**F/YR21/0229/F**

**Land North Of, 39 March Road, Rings End, Cambridgeshire**

**Erect a 2-storey 3-bed dwelling involving demolition of outbuilding**

**Officer recommendation: Refuse**

March Road Elevation  
Scale: 1:200

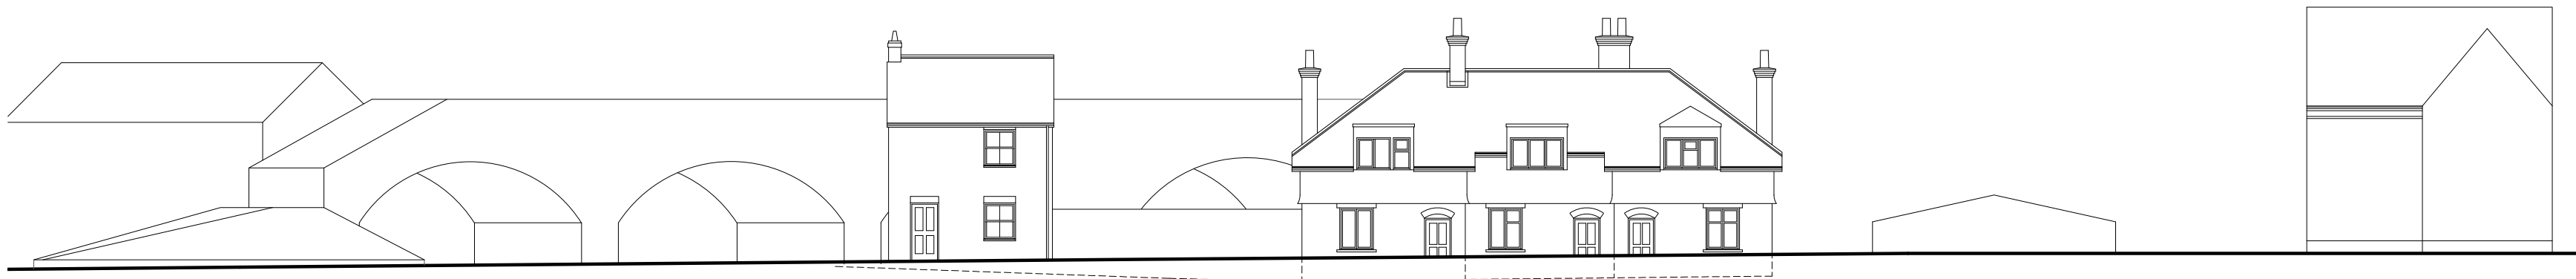
- 10.4 In addition the width of the proposed property has reduced from 9 metres to 5.8 metres this reduction has enabled the dwelling now proposed to sit in line with the existing terrace to the south, as opposed to standing proud of these properties. Consequently, it is considered that the revised scheme overcomes the earlier reasons for refusal outlined above (refusal reasons 1 & 2).

- 10.8 The Planning Inspector in considering the earlier appeal *'acknowledge[d] that the railway arches [were] on a register of Buildings of Local Interest, [however it was the] size of the dwelling proposed in relation to the plot that [was] determinative to my reasoning, rather than the proximity or state of repair of the arches.*
- 10.9 It was the view of the Inspector that the development would *'appear over-scaled and dominant'*. The earlier scheme proposal illustrated a dwelling that had a width of 7.6 metres and an overall height of 8.6 metres to the ridge, albeit these details were not committed. The current scheme under consideration details a dwelling that is 1.8 metres narrower and 1 metre lower in height, consequently it

is considered that earlier concerns have been overcome. There will be gap views of circa 8 metres between the existing terrace and the proposed dwelling and the railway arches will be clearly visible to the northern backdrop of the proposed dwelling.

Site Plan  
Scale: 1:200

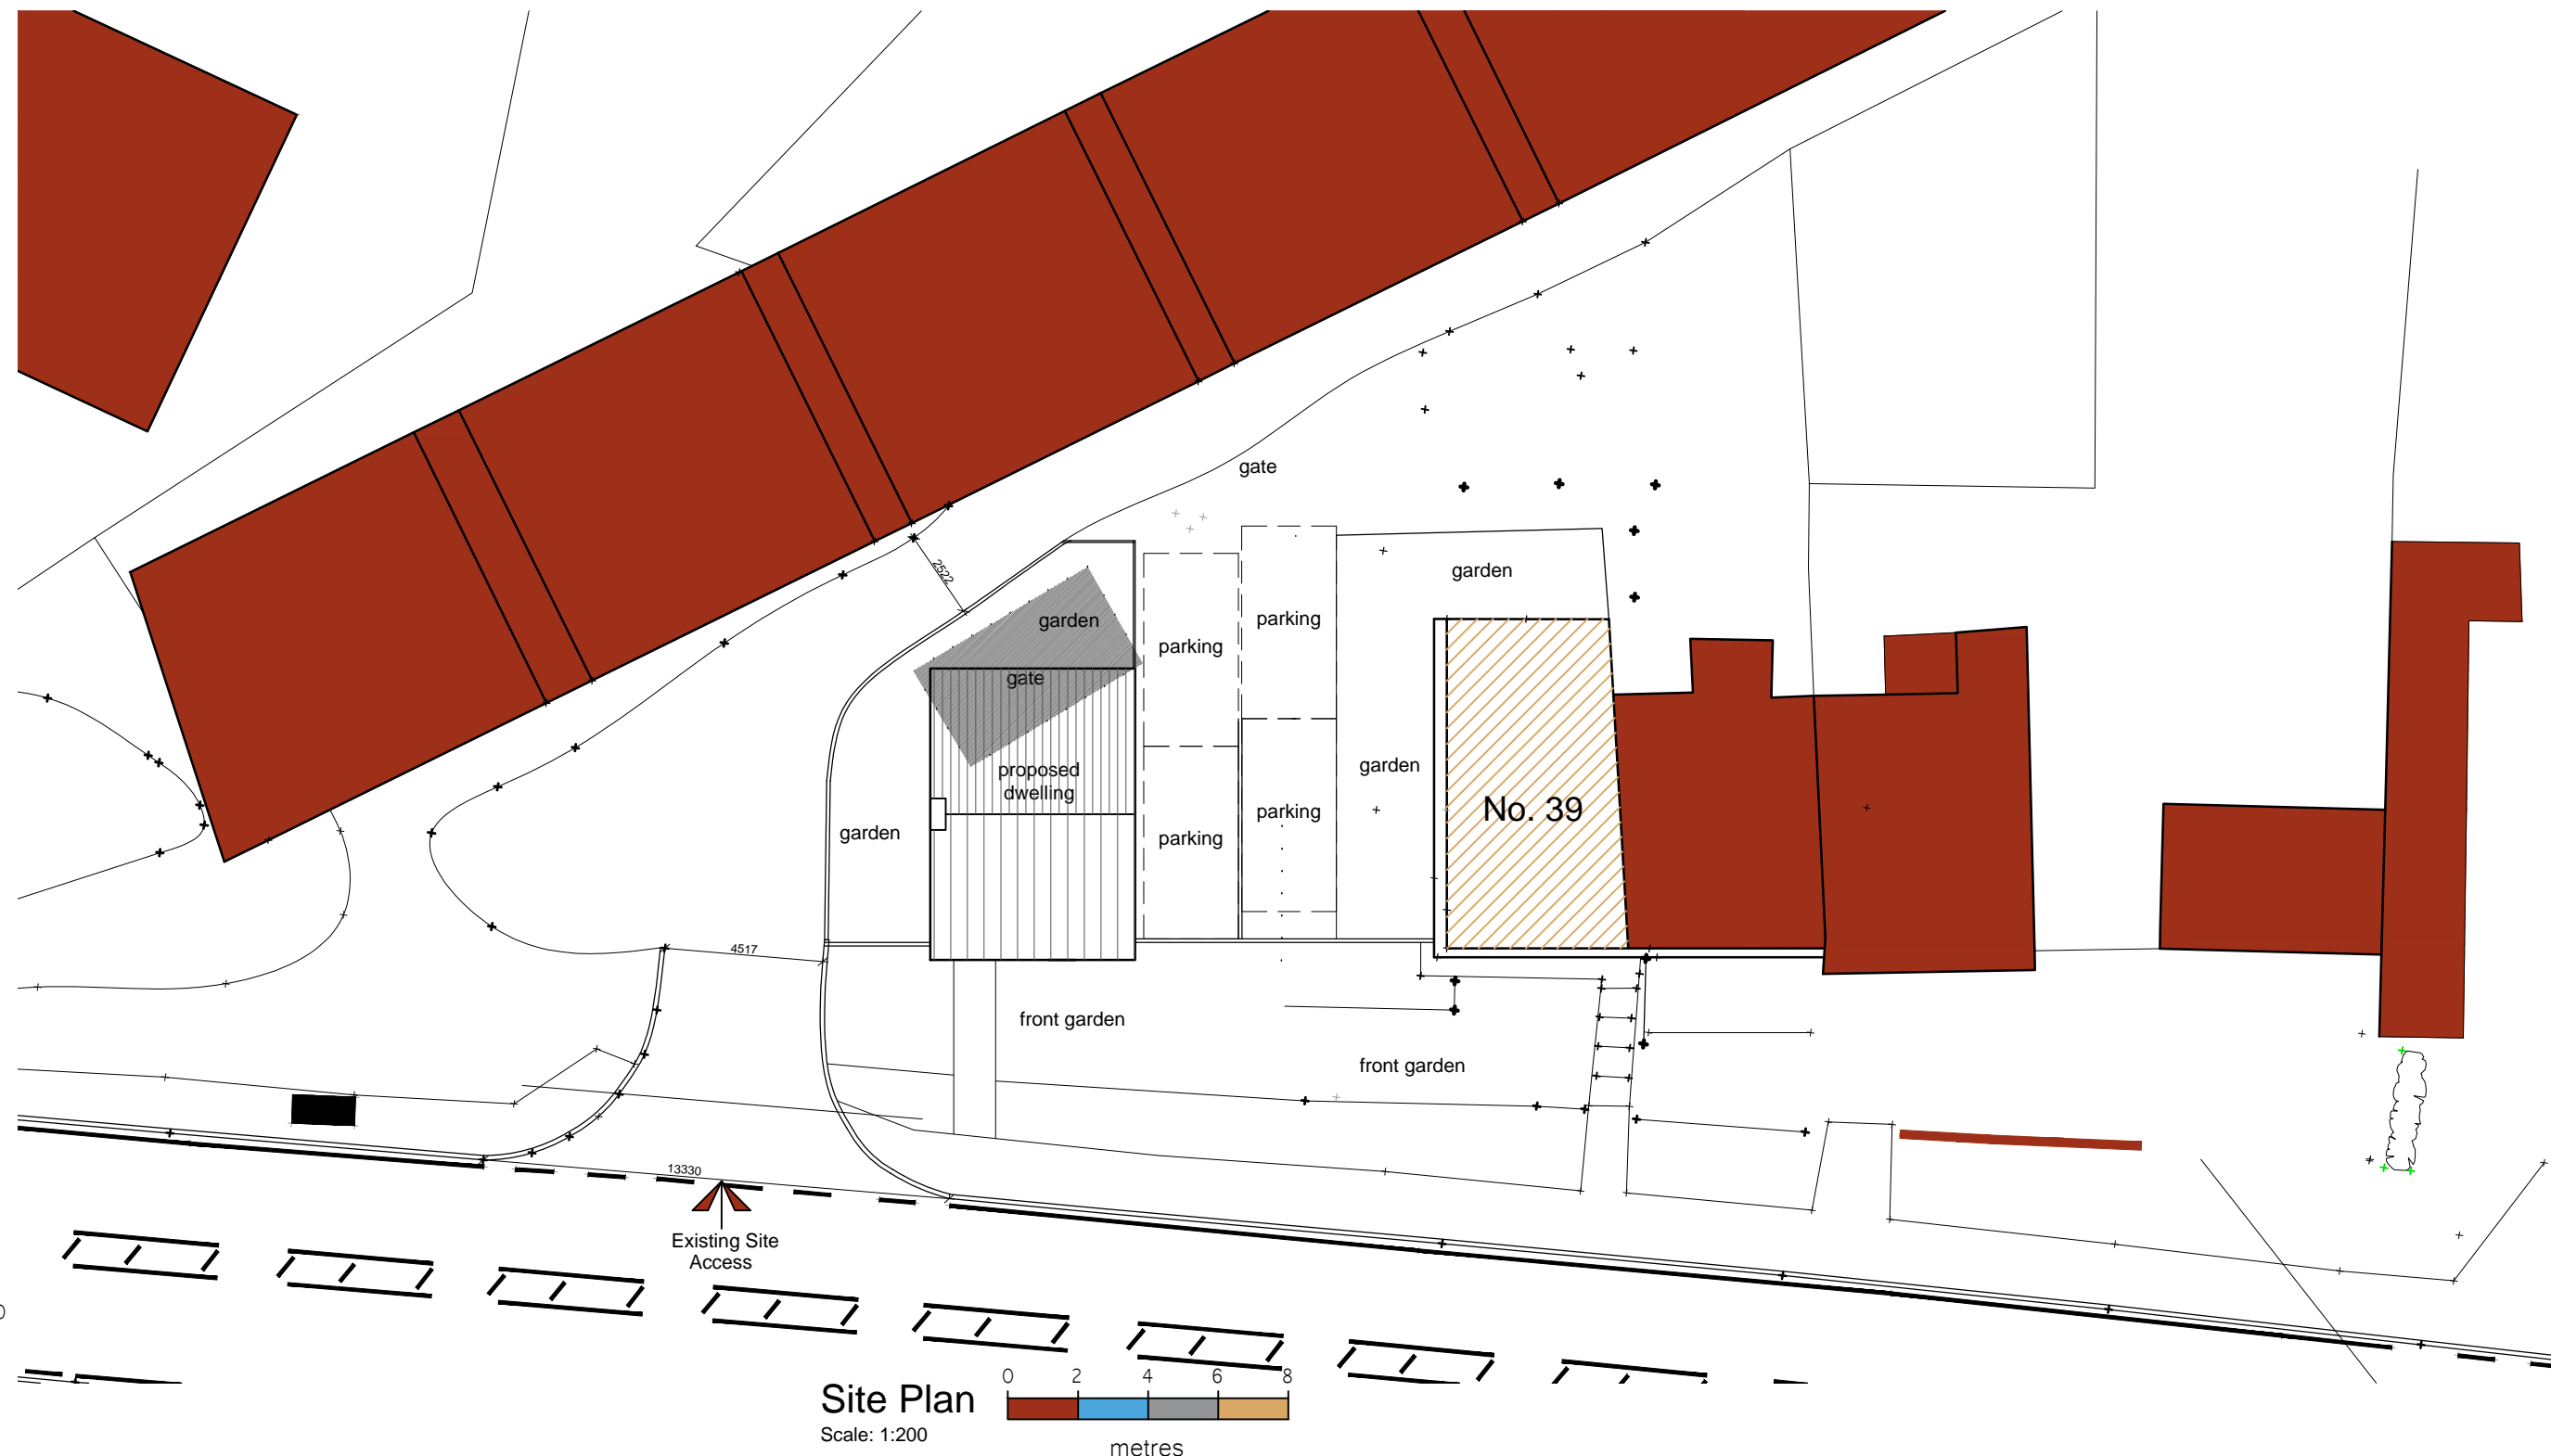
- 10.12 That said the dwelling now proposed introduces new issues in that to compensate for the reduction in width the property, which still retains 3-bedrooms, it has been lengthened by circa 0.8 metres, this combined with the repositioning of the property back into the site, in response to the position of neighbouring dwellings, results in the rear elevation of the property being circa 4.4 metres at its closest point (7.2 metres at its furthest point) from the arches beyond. This is considered to have adverse consequences for the intended householders in terms of overall dominance as the arches will clearly have an overbearing impact, furthermore there will be overshadowing arising as the arches are situated to the east of the property. It should be noted that the separation distance from rear elevation of the house and the arches shown on the illustrative layout submitted under F/YR17/0761/O was circa 6.3 metres (from the projecting 2-storey outshoot detailed) extending to 10.8 metres and circa 7.1 metres extending to 13 metres in respect of the scheme proposed under F/YR20/0508/F. The relationship now shown is clearly an adverse consequence of the scheme now proposed and significant enough so as to render the proposal unacceptable in residential amenity terms.

- 10.13 Furthermore it remains the case that the private residential amenity space provision for the new property will not meet the minimum standards of Policy LP16 (h) providing as it does only 20% of the plot as garden land (excluding access). The garden area is also considered to be convoluted in its layout, wrapping as it does around the rear and side of the dwelling. In addition, the amenity space is further compromised in terms of its quality by the presence of the dominating historic railway arches to the east as highlighted in para. 10.12 above

- 10.14 A similar situation exists with regard to the 'private' amenity space associated with the host property No 39 which would see only 27% of the plot available as private garden (excluding access), as opposed to the minimum third required under Policy LP16 (h).

- 10.20 It is noted that the site layout shows two parking spaces to serve each dwelling (existing and proposed) with appropriate space available to facilitate turning; Given that the parking area to serve No 39 is shown within the blue edge boundary, i.e. land within the control of the applicant such provision may be secured via condition.

| 1 | Policies LP2 and LP16 of the Fenland Local Plan require that proposals for new development promote high levels of residential amenity. Given the relationship between the existing historic railway arches to the east and the dwelling it is considered that the intended householders would have a compromised outlook which would be visually dominated by the historic arches. In addition, the presence of which in arches in such close proximity would result in a level of overshadowing of both the house and garden. As such the scheme will fail to deliver appropriate levels of residential amenity as promoted by Policies LP2 and LP16 and clearly is at odds with the aims of Policies LP2 and LP16 of the Fenland Local Plan (2014).  |
| 2 | Policies LP2 and LP16 of the Fenland Local Plan require that proposals for new development promote high levels of residential amenity with private amenity space being an essential component of such amenity. The scheme proposed fails to make appropriate provision for private amenity space as indicated in Policy LP16 (h) and as such fails to deliver adequate levels of residential amenity as indicated by Policies LP2 and LP16. In addition the presence of the historic railway arches to the north-east of the proposed dwelling will further detract from the amenity value of the already substandard amenity space thereby exacerbating the failure of the scheme to make appropriate provision for private amenity space this being to the significant detriment of the residential amenities of future occupiers and clearly at odds with the aims of Policies LP2 and LP16 of the Fenland Local Plan (2014). |
